## 4.8 Preliminary Design – Cost Estimate

## 4.9 Comments On The Preliminary Design

The following comments on the Final Draft of the Needs Assessment document were received by Chief Alan Michaels.

Figure 68 – Preliminary Design, P25, Trunked Sites, Custer County

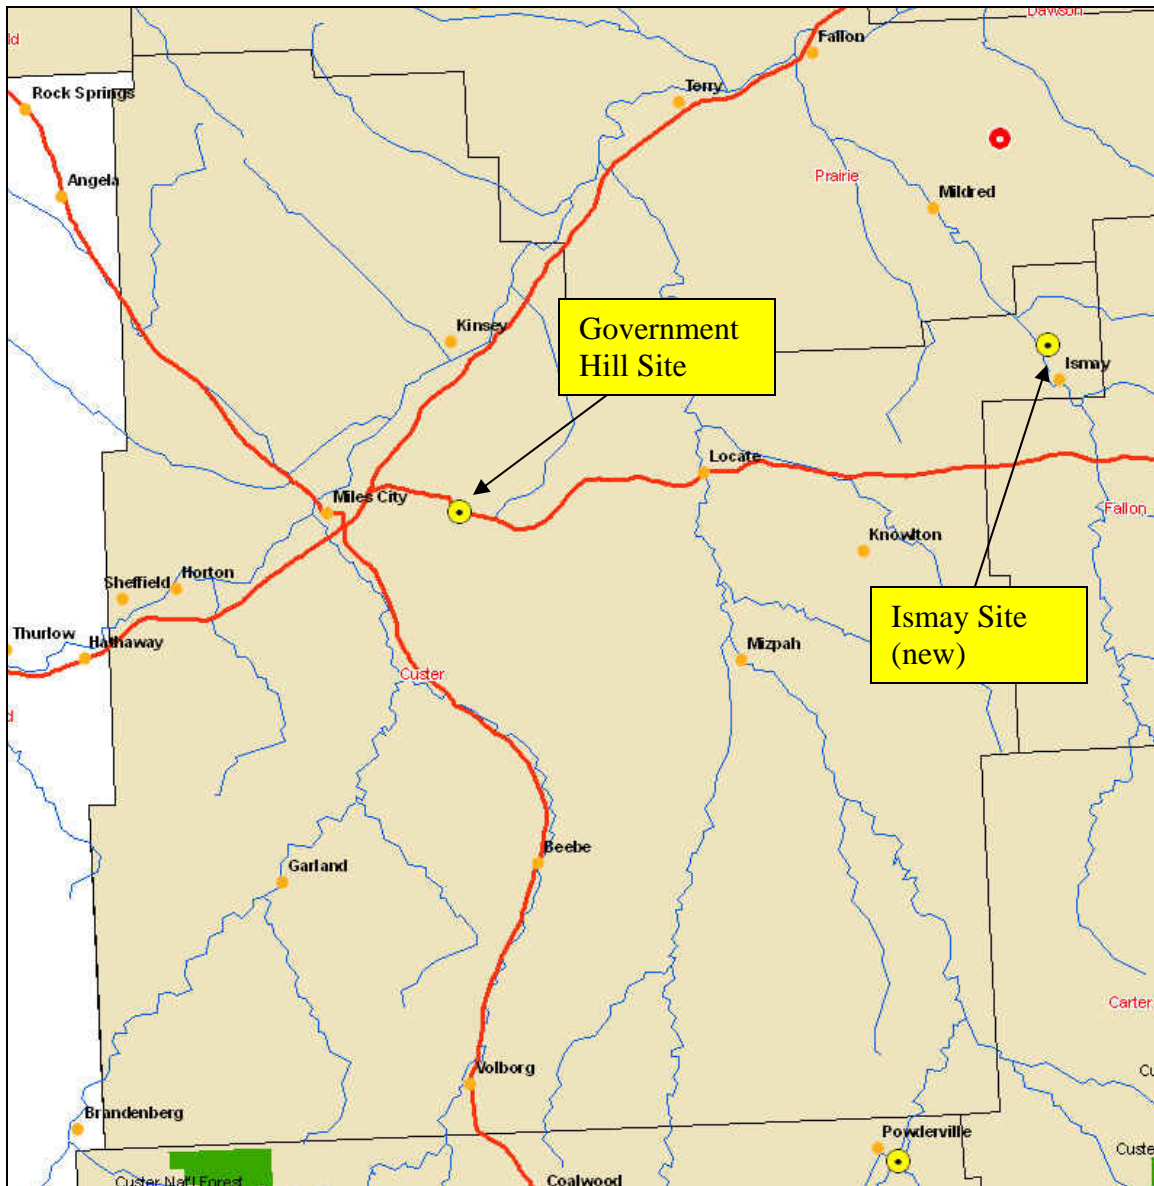
Be advised that the ETIC Interoperable Communications Plan Project Needs Assessment does not adequately address the needs of Custer County.

3. In section 2.3 this assessment states: A plan which is affordable and a practical system to meet immediate and future needs. We are very concerned about the cost of this project. \$13,500,000.00, for this project is excessive and we have concerns that this project will never be fully built.
4. Goal of the ETIC to become P25 compatible. Since all future Homeland Security grants are now being diverted to the ETIC there is no money available to upgrade existing communications equipment and systems to P25 compatible within Custer County. Our agencies can not afford to spend \$1700.00 for a handheld, \$3200.00 for a 100 watt mobile and \$20,000.00 for a repeater to become P25 compatible.
5. Two P25 trunked sites will not adequately cover Custer County. Additional trunked sites are needed at Knowlton, Moon Creek, Kinsey, Mizpah area and in northwestern Custer County.”

After reviewing the proposed Eastern Tier Interoperability Consortium Project Plan, I have several concerns. It does not appear that the P-25 Trunk Sites will cover Custer County in its entirety. With personal knowledge of this county the North, South and Western parts will still not have radio coverage as the plan is now drafted. It appears that Dawson County is well covered for its area. Custer County must be addressed in much the same way.

There is obviously serious concern in Custer County that the preliminary design does not provide adequate coverage for the county. In this respect, the preliminary design has met its primary goal, which is to serve as an instrument to stimulate discussion and refinement.

The next phase of the project will contain several iterations of the design, as more and more decisions are made and more and more facts become known. One of the first steps should be to validate the coverage in Custer County using scientific means, such as coverage propagation maps using more refined assumptions about antenna heights, locations and power.

The question from a consortium viewpoint must be, “Will all counties in the consortium be adequately covered,” not “Which counties are the sites located in?” When the preliminary design was created, the communications engineers from TAB Electronics and East-Mont Communications believed the coverage from the sites surrounding Custer County would be

adequate to cover Custer County. They may be wrong, and if they are, the next phase of the project will determine that for a fact, and the design will be changed.

The specific questions which must be answered with respect to Custer County are:

1. Will the proposed Big Sheep Mountain site in Prairie County provide adequate coverage for the northern and northwestern areas of Custer County?
2. Will the proposed Ismay site in Custer County provide adequate coverage for the far eastern and Knowlton areas of Custer County?

3. Will the proposed Government Hill site in Custer County provide adequate coverage for the Mizpah area of Custer County, as well as the area directly west of Miles City?

4. Will the proposed Powderville site in Powder River County provide adequate coverage for the southeastern portion of Custer County?
5. Will the proposed Home Creek site in Powder River County provide adequate coverage for the southwestern portion of Custer County?

6. Will the overlap of the Home Creek and Powderville sites provide adequate coverage for south-central Custer County?
7. Is there a site in Rosebud County near Rosebud or Forsyth that will provide adequate coverage for the area west of Miles City and possibly overlap with the coverage area from the Government Hill site? Rosebud County is in the Big Sky 11 consortium. It was not known at the time of the creation of this document what the final plans were for that area of that consortium.

If the answer to one or more of these questions is no, then the communications engineers must once again be consulted during phase 2 to determine how to make up for the deficit(s).
